POUR/ZONE No. 1C3, 1C7, 1C10		FLOW DIAGRAM I-2-5114A	
REQUIRED COMPLETION DATE	FABRICATED BY TUBECO	Q.S.L. 21	WELD PROCEDURE SEE NOTE 2
REVISION RECORD		LIVSEY & COMPANY, INC.	
NO.	DATE	DONALD C. COOK NUCLEAR PLANT	
		CONTAINMENT BLDG	
		DWG. NO.	
		1-NSW-70	
		SH 2 OF 2

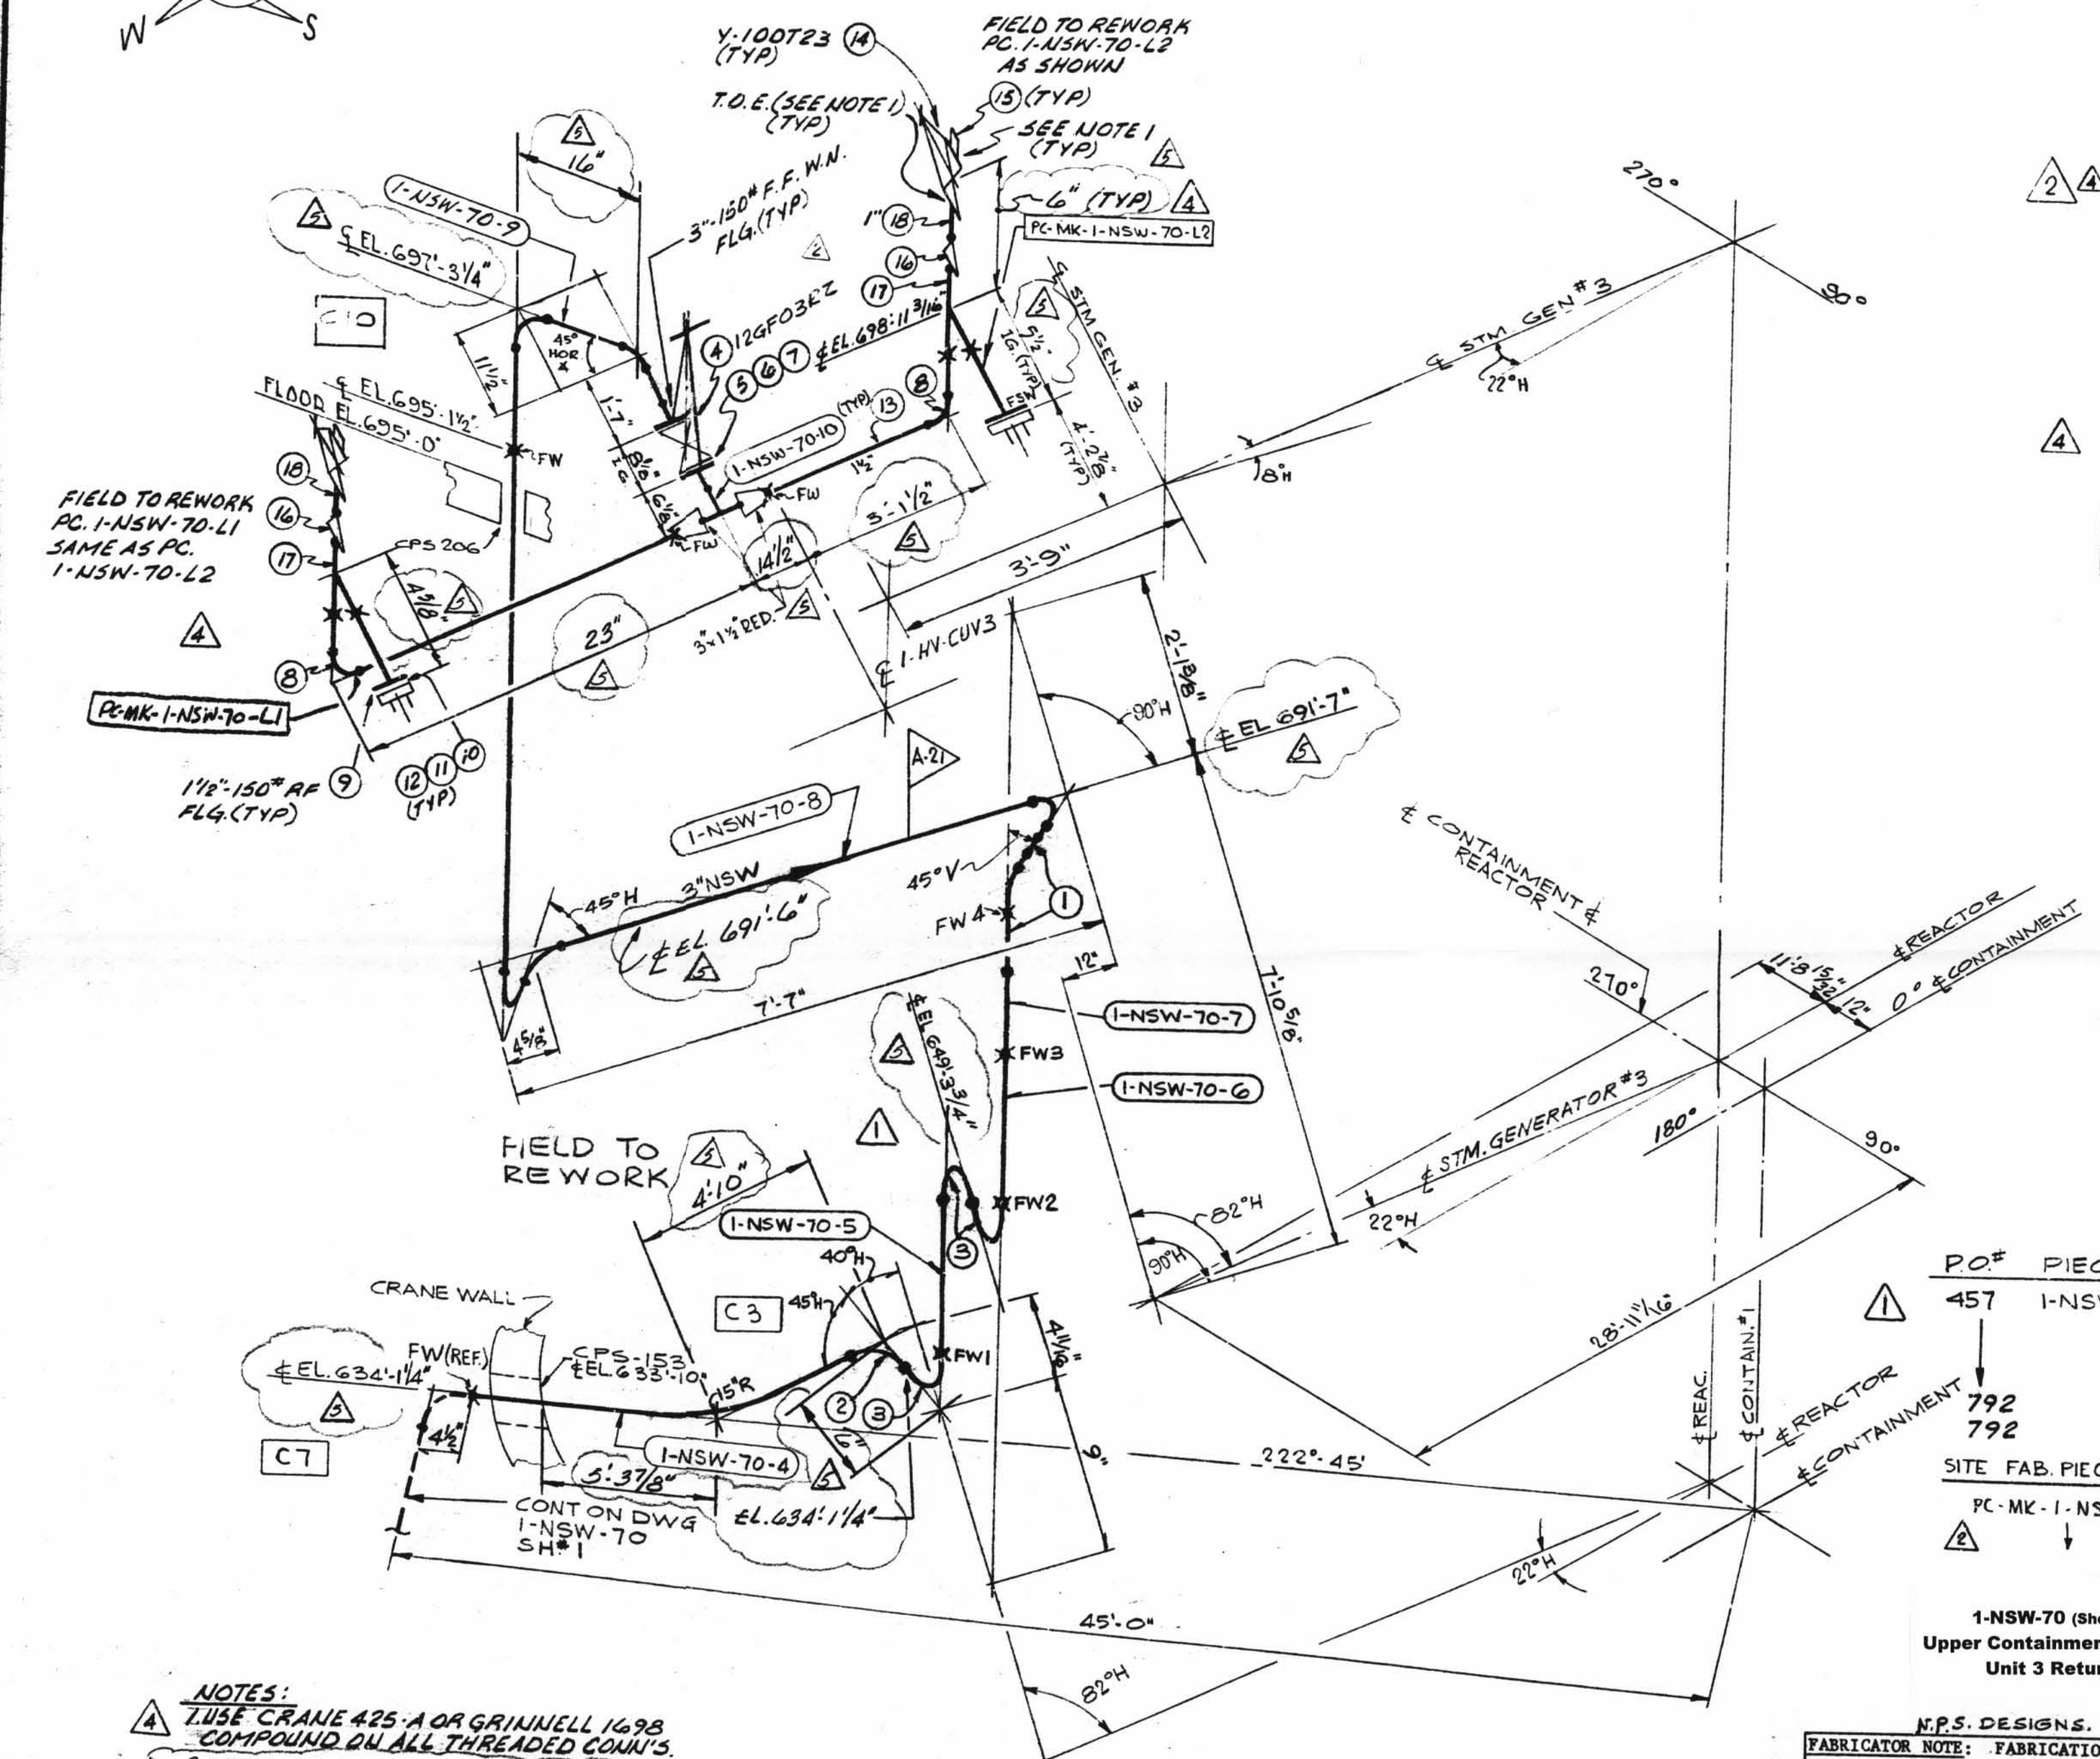
REV	DATE	DR	CHK	DESCRIPTION	REMARKS
1	4/10/72	JQ	GN	REVISED PIPING & ADDED NOTE FOR FIELD REWORK FOR PC MK 4 THRU 8. ADDED: ITEMS 1, 2 & 3; PO.#; BOX FOR TOTAL NO. OF FW'S. DELETED: WELD PROCEDURE PER A.E.P. DWG 1-5489A-2.	FIELD ACTION REQD
2	6/15/72	CEM	EP	ADDED: SPOOLS 9 & 10; PC-MK-1-NSW-70-L1/L2; BILL OF MATL. ITEMS 4 THRU 13. PER AEP DWG 1-5740-REV. 1. ADDED REF. DWG. 1-5740. REV. BY NRS DESIGN	FIELD ACTION REQ. FAB ACTION REQ.
3				BY FIELD	
4	2/11/73	J.Q.	GN	ADDED: 1" VENTS & RENOVATED PCS 1-NSW-70-L1 & L2 TO SUIT. ADDED ITEMS 14 THRU 18 & CHANGED QTY OF ITEM 8. ADDED AEP A.A.G.T. DWG. 1-5740-5	FIELD ACTION REQD
5	1/11/74	GR	RT	ADDED: NOTE #2 DIMS. 1 1/2" 15/16" 4" 10" 5" 3 1/8" EL. 697' 2 1/2" 697' 3 1/4" 634' 1 1/4" 614' 6" WAS MIN. 3 1/16" WAS 3 1/4" 1 1/2" WAS 3/4" 2 3/4" WAS 2 1/2" 5 1/2" WAS 4 1/2" EL. 697' 3 1/4" WAS 697' 3" 697' 1 1/2" WAS 697' 0" 649' 3 3/4" WAS 649' 1 3/4" 634' 1 1/4" WAS 634' 1" PER AS BUILT DIMS. AEP DWGS. 1-5489A-4 & 1-5740-6	NO ACTION REQ'D.
